**Town of Kittery  
 Planning Board Meeting  
 October 13, 2022**

**28 Wyman Avenue — Sketch Plan Review, Cluster Residential Subdivision**

**RE: Town of Kittery, Planning Board Services  
Wyman Hill Cluster Subdivision  
28 Wyman Avenue, Tax Map 16, Lot 148  
CMA #591.151**

SHEET NUMBER:  
**C - 3**

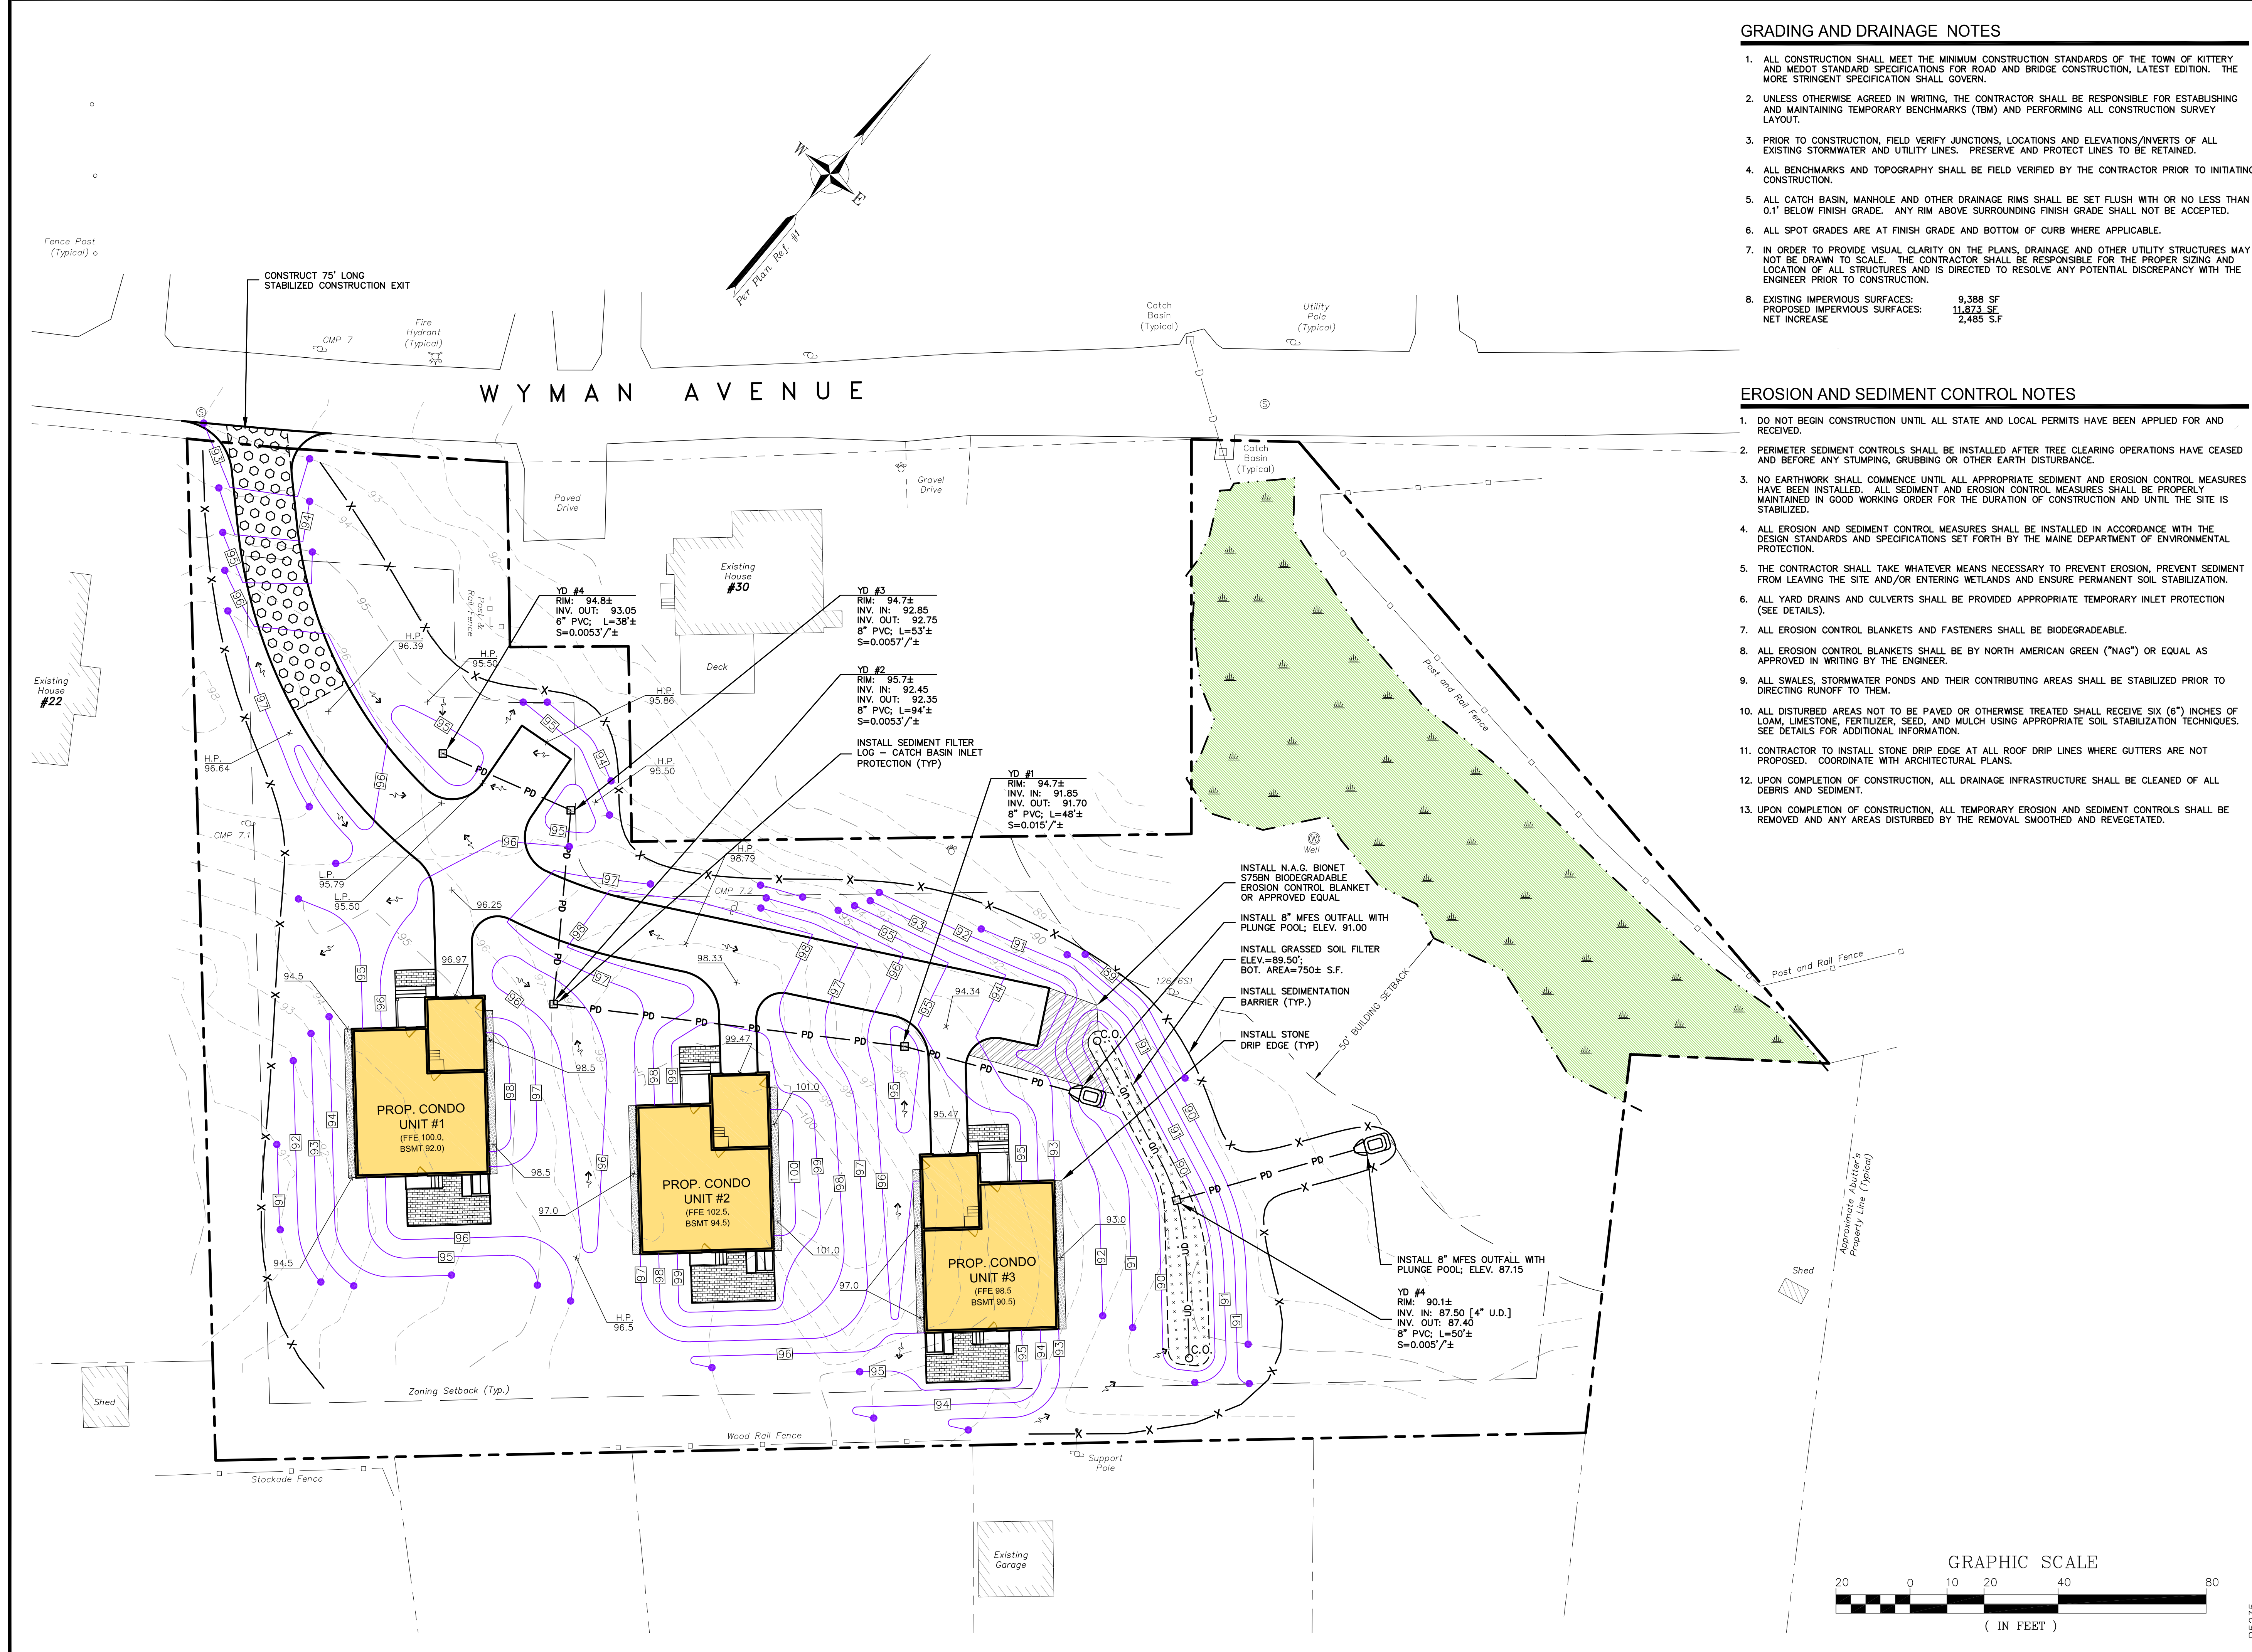
- Note 9 should read "grassed soil filter" not "stormwater pond".
- Note 13 should read upon "establishment of vegetation, all temporary erosion and sediment controls shall be removed" not "upon completion of construction".
- YD #4 should be identified as the outlet structure on the plan.

TITLE:  
**UTILITY PLAN**  
 SHEET NUMBER:  
**C - 4**

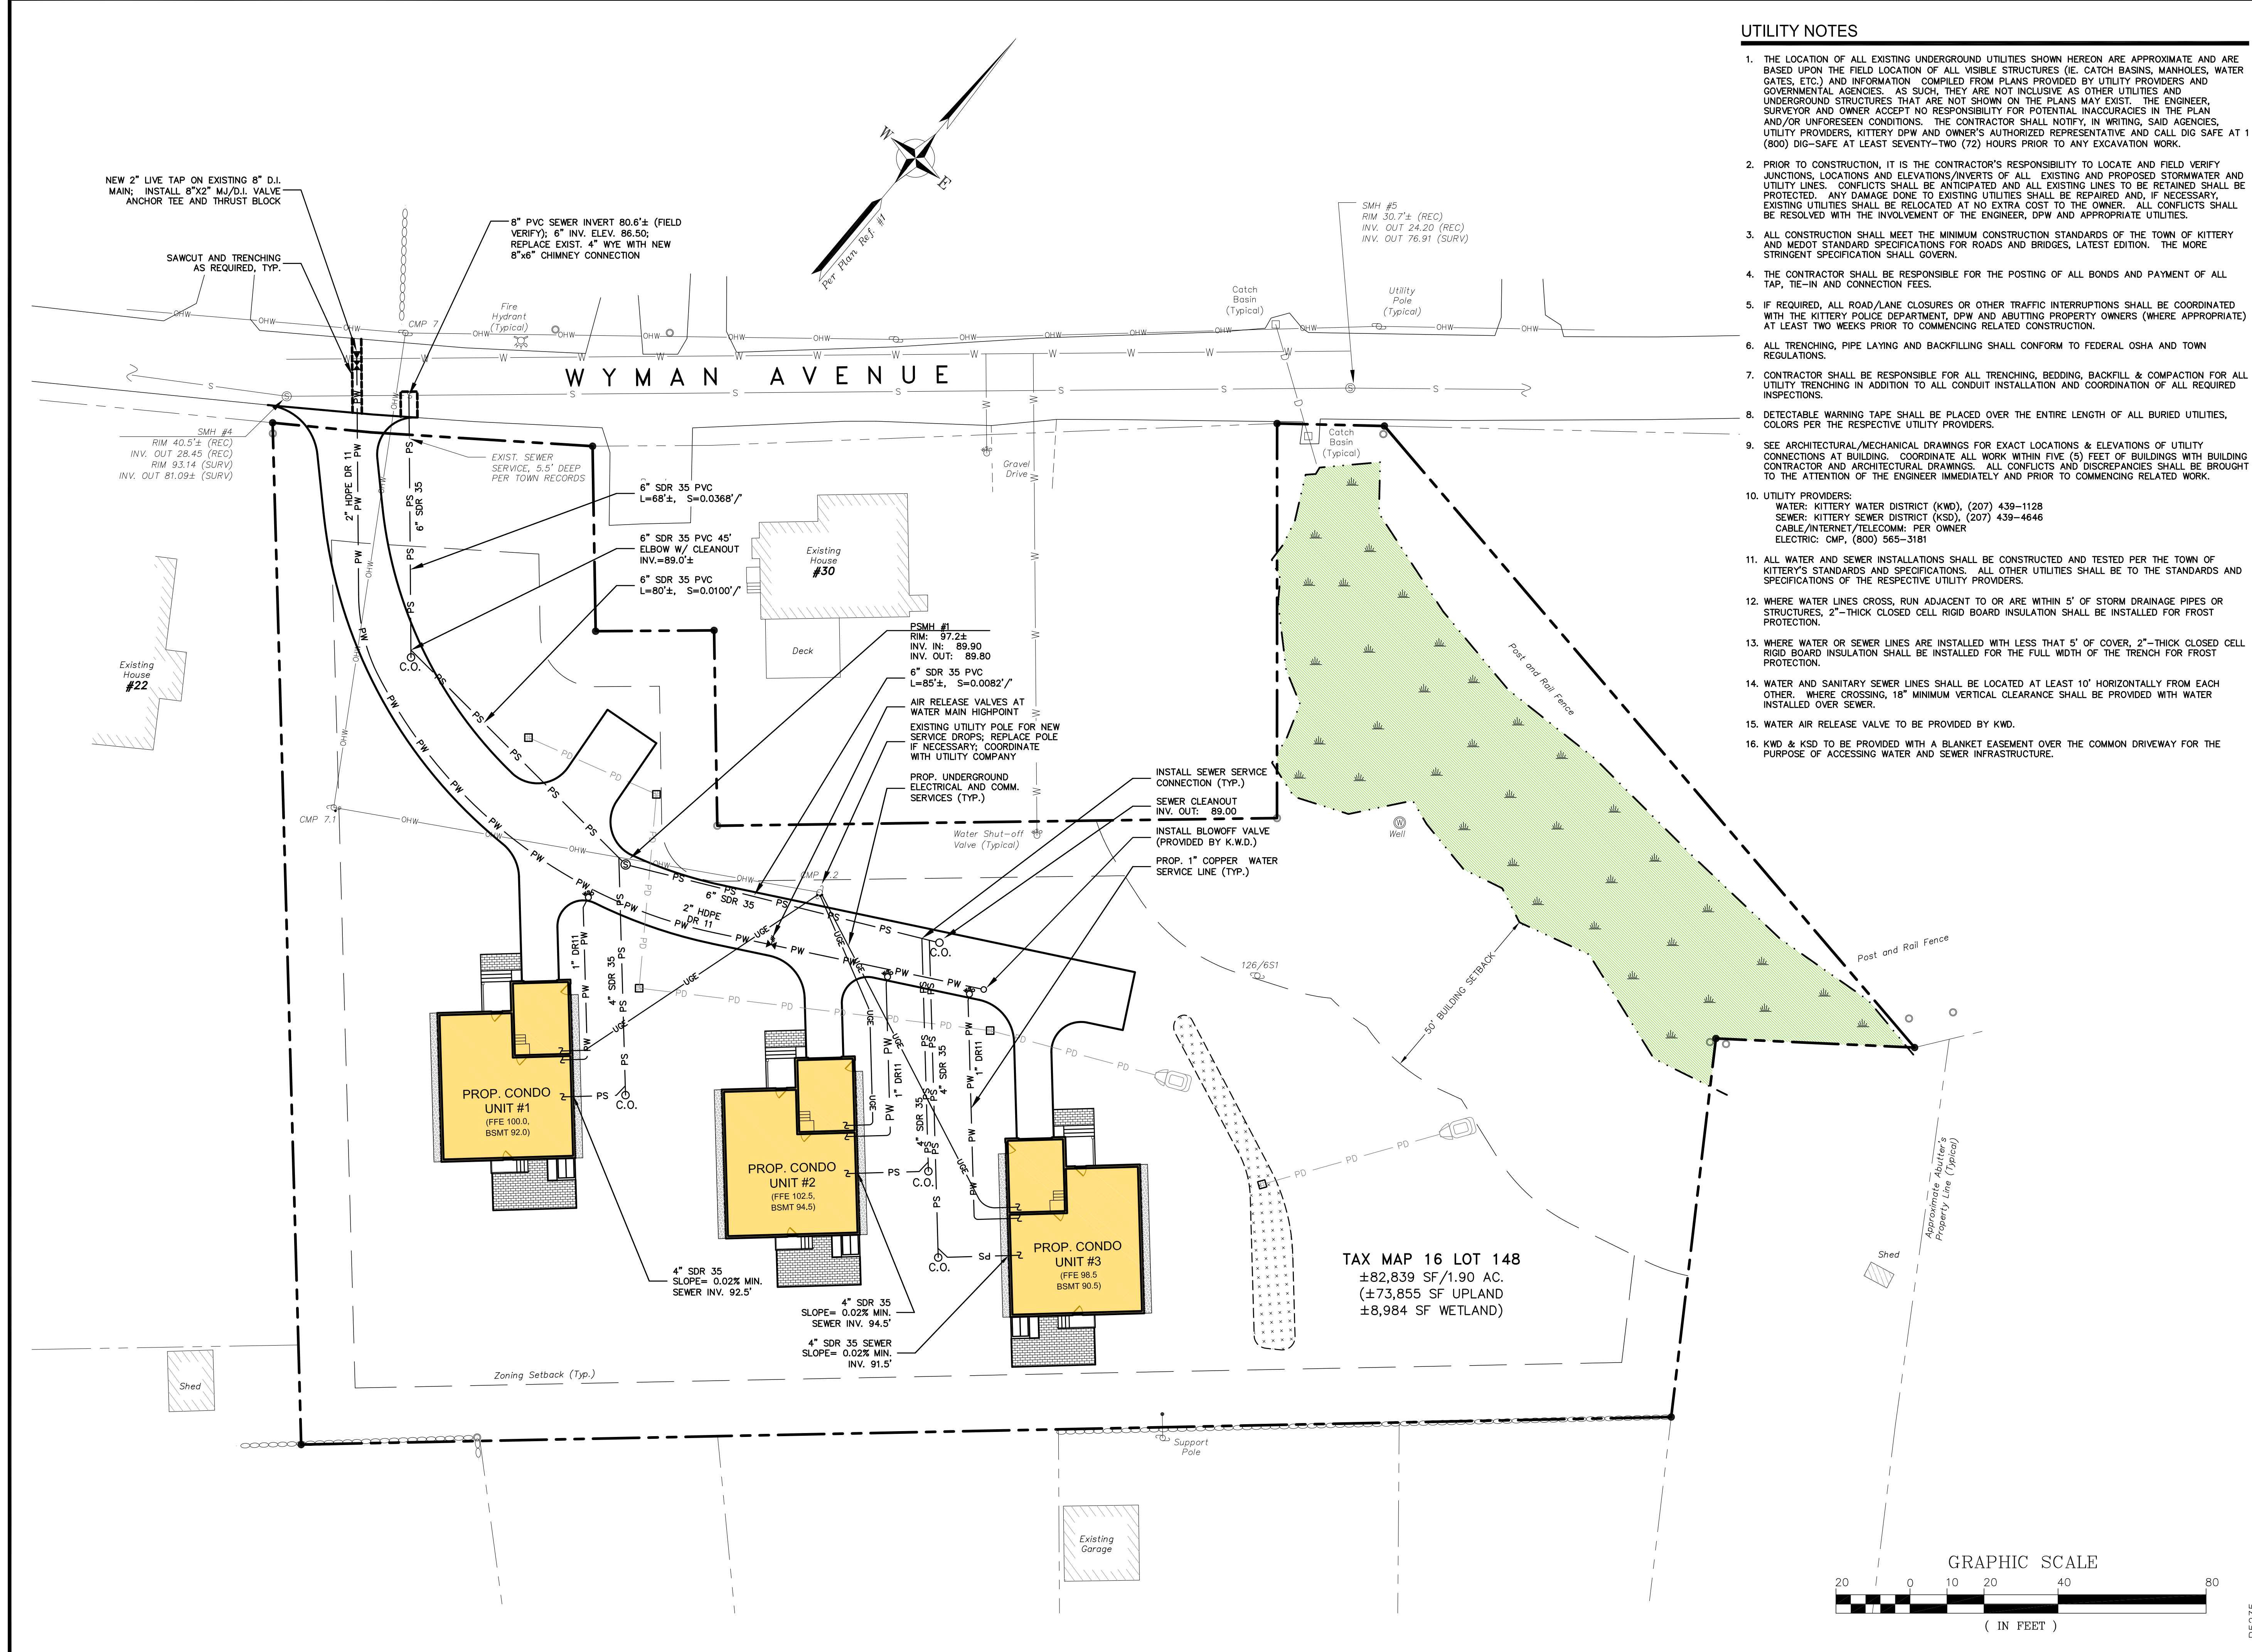
55 The site plan (sheet C-4) shows the plan for utility services. The plan shows using an existing sewer  
56 connection, as well as using an existing water connection. Existing overhead electrical lines will terminate  
57 at a new pole where underground electrical service will extend to each condo unit. A stormwater  
58 management plan has been supplied with drop inlets connected to an outfall at the eastern edge of the  
59 property. This outfall appears to be located in an area labeled “Common Area” on other plan sheets.  
60

- The plans should include a profile of the roadway/driveway with utilities.
- Add existing main materials and sizes to the plan.
- Add existing service materials and sizes to the plan.

- SMH #4 has two rim elevations and two invert out elevations (REC and SURV). Please remove the ones that are inaccurate.
- Add the invert in to SMH #4 and SMH #5.

- The proposed sewer main shows a 45-degree elbow and cleanout in the roadway. This is unconventional. A sewer manhole structure should be placed at the change in sewer main alignment.

- The proposed sewer main shows a cleanout located in the driveway at the terminal end. This is unconventional. A sewer manhole structure should be placed at the end of the sewer main. In addition, the terminal cleanout invert is below the inverts in PSMH #1.

- The 6" invert elevation of the proposed connection to the sewer main in Wyman Ave is approximately 6' above the invert of the existing main. Is this correct? If so, the applicant should install a sewer manhole with interior drop at the tie-in location as a 4" wye with 8" x6" chimney connection is unconventional.

**TYPICAL GRASSED SOIL FILTER (GSF)** NOT TO SCALE

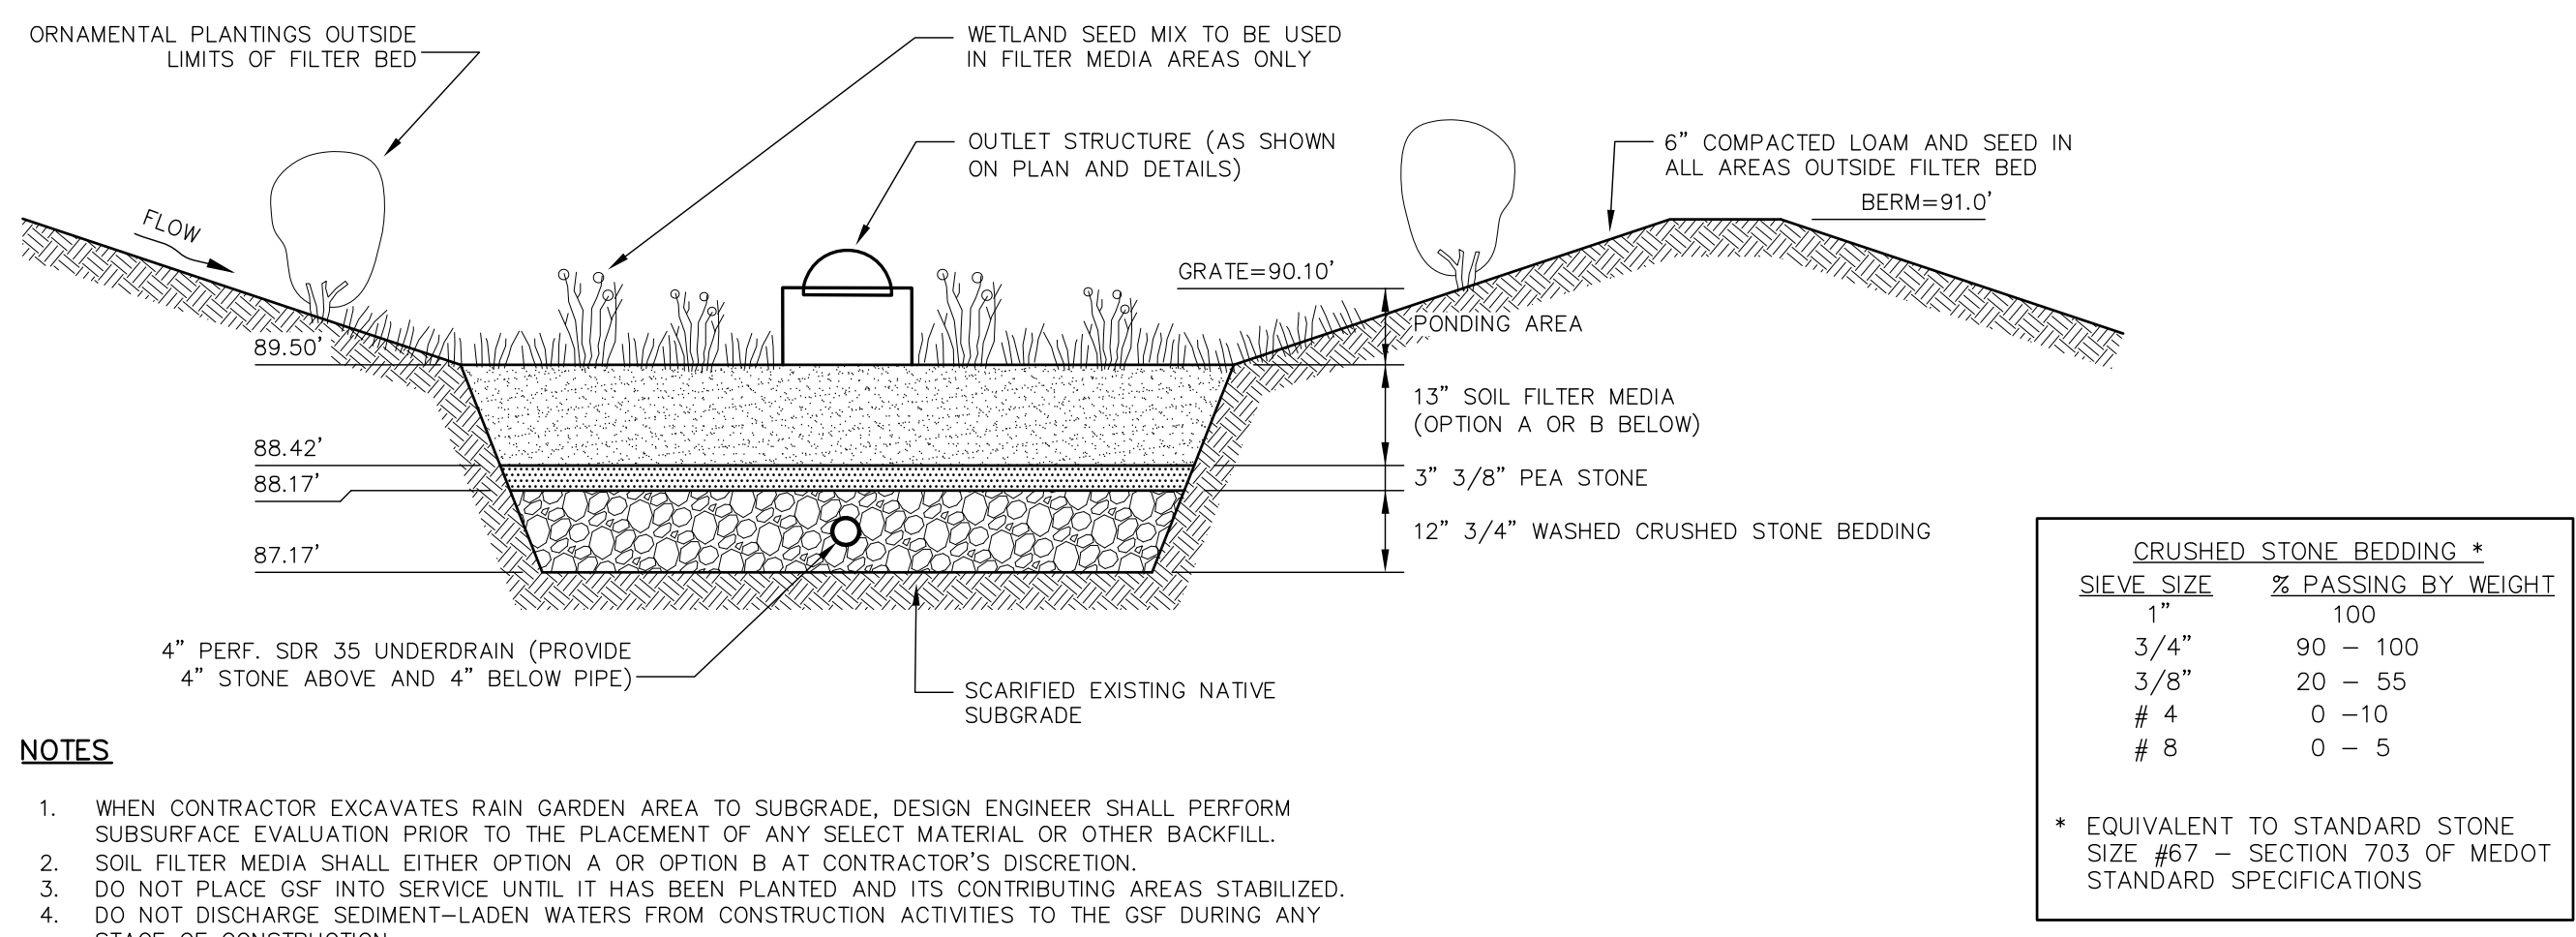
- Note 1 for the Typical Grassed Soil Filter detail should reference a grassed soil filter not a rain garden.
- The Typical Grassed Soil Filter detail should label the outlet structure YD #4.
